No. 96-16

Hurth V-Drive Output Flange Torque

73013

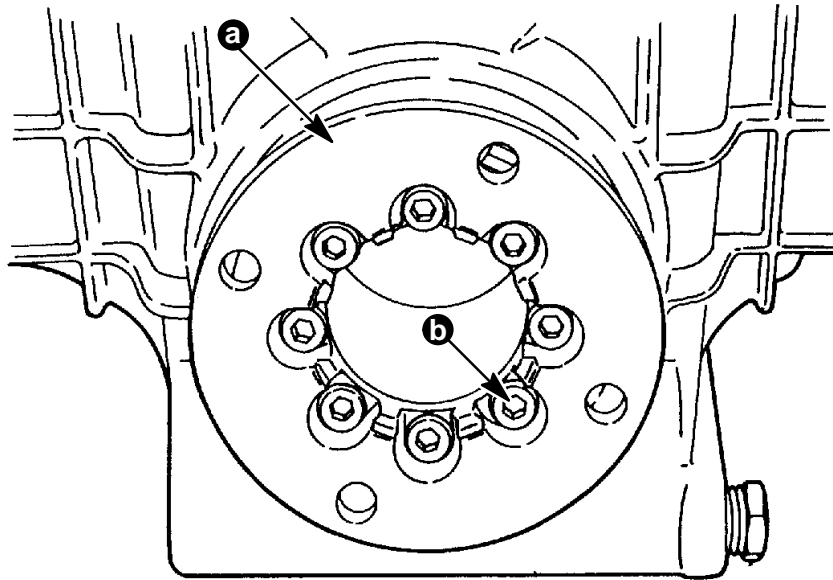
The output flange torque figures listed in #12,#15,#16, #19 and #21 Service Manuals are incorrect. The torque for the output flange is **listed** as 14 lb. ft. (18 N.m).

The output flange should be installed on the output shaft. Apply Loctite Type A to the threads of the bolts and **torque to 28 lb. ft. (36 N.m)**.
